Fuel Oil Fill / Vent - Contract Drawings vs. Now (RFI#26)

PROJECT: SEAFARERS 18 VESEY ST	**CM: KBD GROUP**
ENGINEER: ACE	**ARCHITECT: ARACARI & IOVINO**
NORTHERN WOLVES RFI#: 02	**DATE: 08-20-2026**
SUBJECT: ALTERNATE FUEL OIL LOCATION	**DRAWING NO: FO-SC**

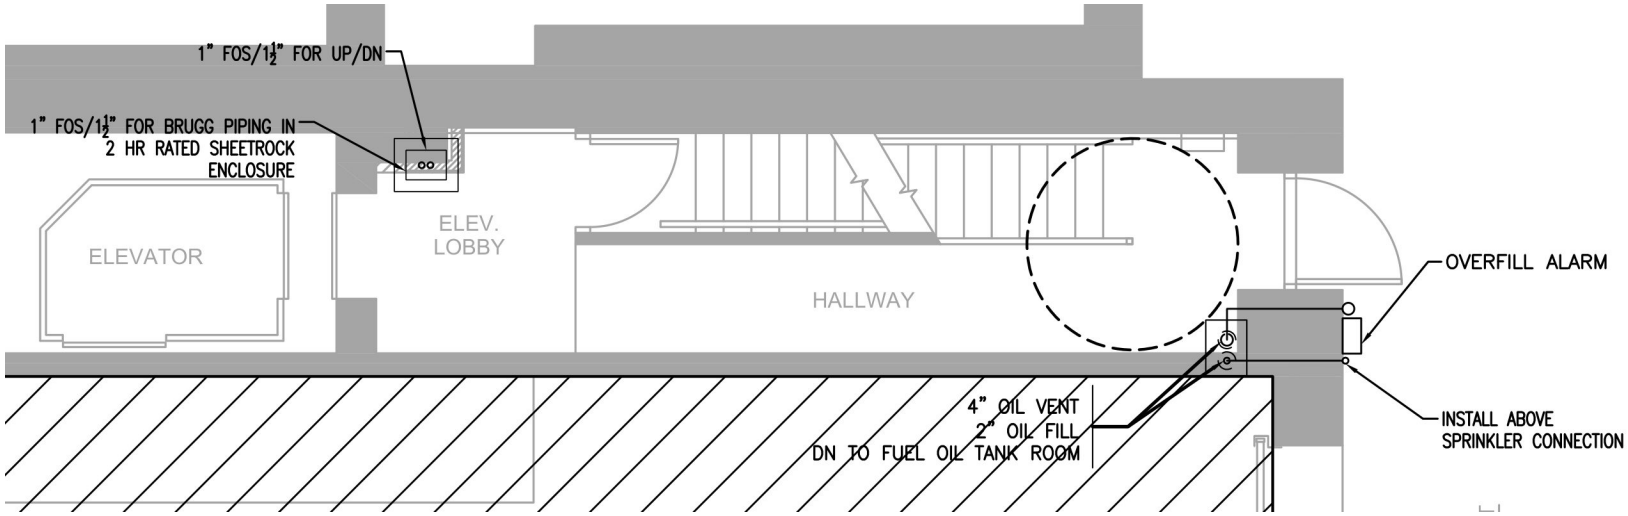
Contract drawings (IFB 1/8/2026)	Now (RFI#26, ACE response 8/25/2026)
Location	Vesey St facade, 1st floor, east end of the hallway at the exterior door, "INSTALL ABOVE SPRINKLER CONNECTION" (FS102). Driveway to 10 Barclay St is hatched "NOT IN SCOPE OF WORK".	Option 2: fuel oil box on the side wall inside the garage (driveway to 10 Barclay St). ACE: "CONFIRM OPTION 2".
Fill terminal	"2" WALL MOUNTED FUEL PORT" on the facade (FS300). No fill box or spill bucket detail.	Fill box on the garage wall, "approx. location 2 feet away vertically from garage door and 2 feet horizontal", "confirm 2 feet away from building door".
Vent	4" FOV terminates on the facade, min. 2'-0" above the fill port, with the overfill alarm (FS300, MC 1305.7.2).	"We need to stick out of the building" / "2 feet above garage door opening": the 4" vent runs up the outside wall and terminates 2 ft above the garage door opening, 2 ft from building openings.

Routing	From the tank room up through the sub-cellar and cellar (own 2-hr enclosure, FS101) to the facade. Shop drawing Rev.03 (10/13): FOF 93'-7", FOV 95'-2" - still to this location.	Not drawn yet. Fill and vent were excluded from the 19.2 approval (10/20) and must be resubmitted at the new location.
Who asked	-	NWAC's RFI#02 (8/20/2026), logged by KBD as RFI#26, asked for Option 1 (sidewalk above the cellar vault) or Option 2 (garage wall). The reason is not stated in the RFI.

3. Now - RFI#26 (NWAC RFI#02), 1st floor plan with options and ACE response

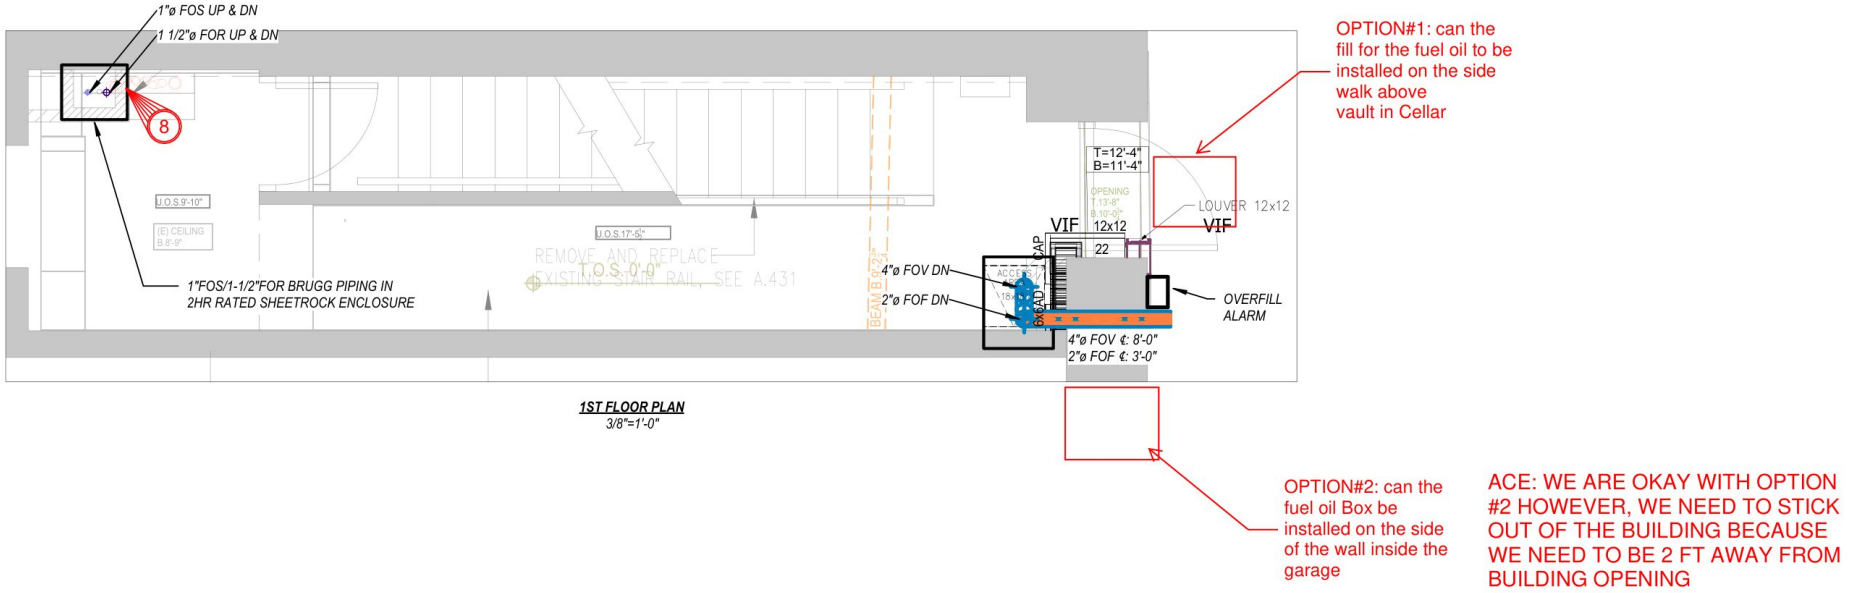
Shop drawing FO-SC 1st floor with Option 1 (sidewalk above the cellar vault) and Option 2 (box on the garage side wall). ACE: "We are okay with option #2 however, we need to stick out of the building because we need to be 2 ft away from building opening."

4. Now - RFI form with ACE answer, and ACE photo markup of the garage entrance (RFI#26)

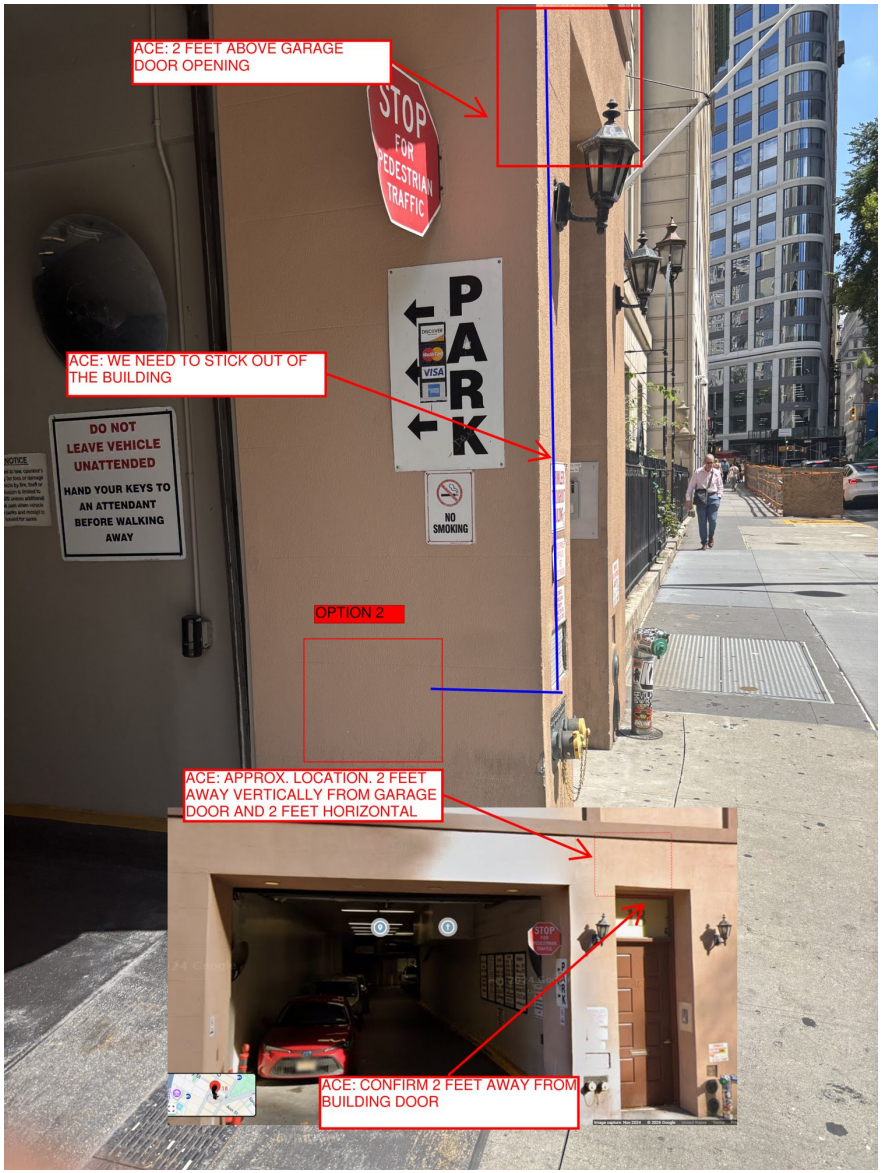
Per drawing FO-SC, the fuel oil fill piping (1" FOS / 1-1/2" FOR) is currently routed to the fill location shown on the referenced drawing. Northern Wolves is requesting confirmation on two alternate fill locations for review:

Option 1: Install the fuel oil fill on the sidewalk directly above the vault in the cellar (see marked location, attached 1st Floor Plan).

Option 2: Install the fuel oil box on the interior wall inside the garage, in lieu of the location currently shown (see marked location, attached 1st Floor Plan).

Please advise which option is acceptable, or confirm the fill location shown on the current design intent.

ACE: CONFIRM OPTION 2 HOWEVER, WE NEED TO HAVE THE VENT PIPE 2 FT AWAY FROM BUILDING OPENING. WE NEED TO STICK OUT OF THE BUILDING

ACE: "Option 2" box on the garage wall; vent "we need to stick out of the building", "2 feet above garage door opening", "approx. location 2 feet away vertically from garage door and 2 feet horizontal", "confirm 2 feet away from building door".
